DEVELOPMENT REVIEW COMMITTEE (DRC) COMMENT REPORT

PROJECT NAME: Fort Lauderdale Edition Hotel and Residences

CASE NUMBER: UDP- PDD23001

REQUEST: Site Plan Level IV Review: Rezoning Request from A-1-A Beachfront Area District (ABA) and North Beach Residential Area District (NBRA) to Planned Development District (PDD) and application for Prior Zoning Regulations to exceed Floor Area Ratio with Associated Site Plan for 176-Room Hotel, 25 Multifamily Residential Units, and 2,424 Square Feet of Retail Use

GROUND FLOOR PLAN (SHEET E 6)

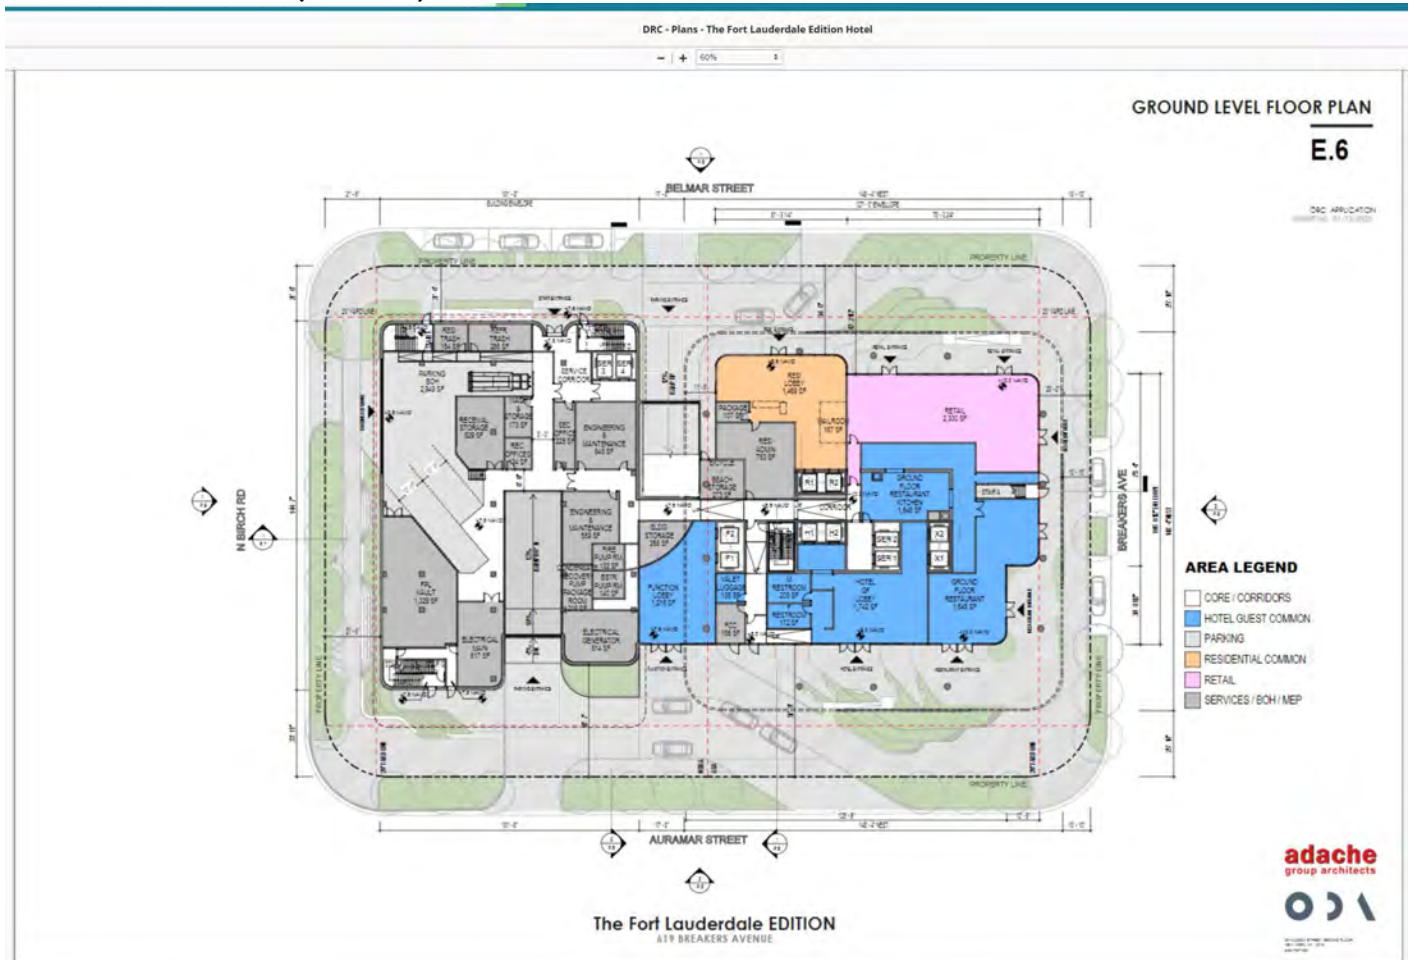
Provide elevations of ground floor (first floor) and any floors below BFE using the NAVD 88 DATUM on Architectural floor plan. The base flood elevation is 6 ft NAVD + 1 'Freeboard= 7 ' NAVD 88.

Show all FFE elevations below the (Base Flood Elevation 7' (BFE) NAVD 88.) and all enclosed rooms below and floors below BFE Base Flood Elevation on the following (sheet E6 attached)

Finish Floor Elevation should meet BFE 6' + 1' Freeboard = 7' NAVD 88. The preliminary flood maps show (panel 388J), (Flood Zone "AE"), with a base flood elevation of 6' + 1'FREEBOARD =7' NAVD 88 NAVD. Show all FFE elevations below the 7' NAVD 88.) and all enclosed rooms.

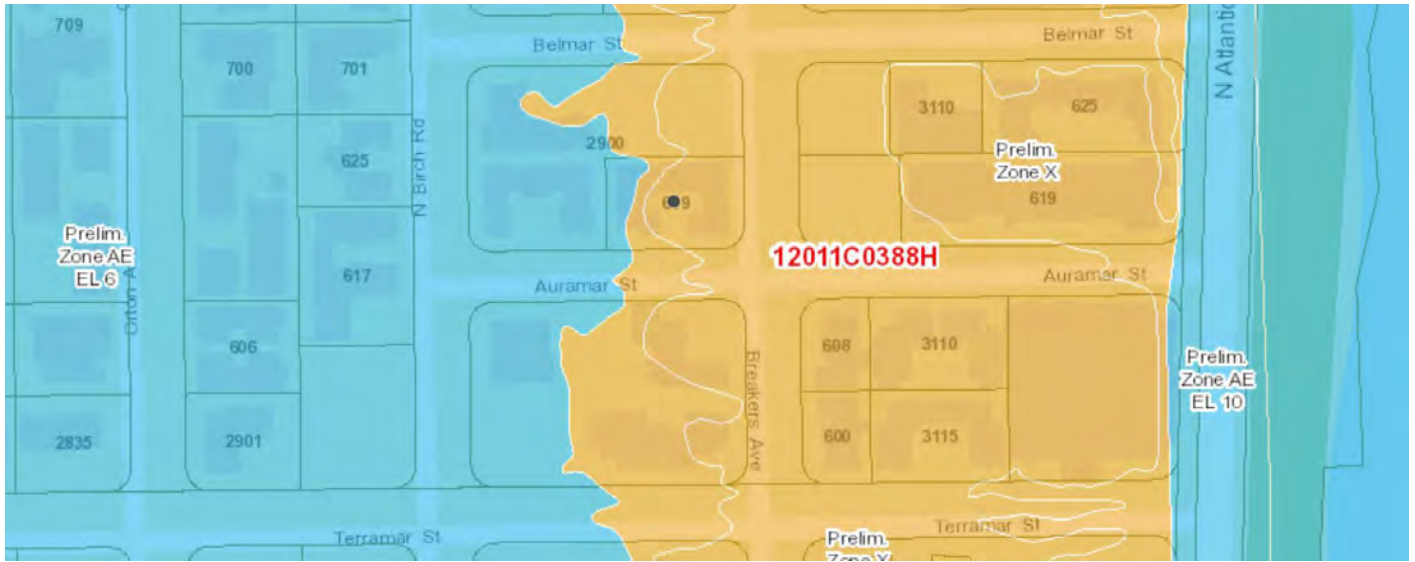
The preliminary flood maps show below (panel 388H ON THIS MAP which is actual 388J FOR THIS PRELIMINARY FLOOD MAP), (Flood Zone "AE"), with a base flood elevation of 6' + 1'=7' NAVD 88 NAVD

The 2014 Flood insurance Rate Maps (FIRM), 388H, X500) see attached.
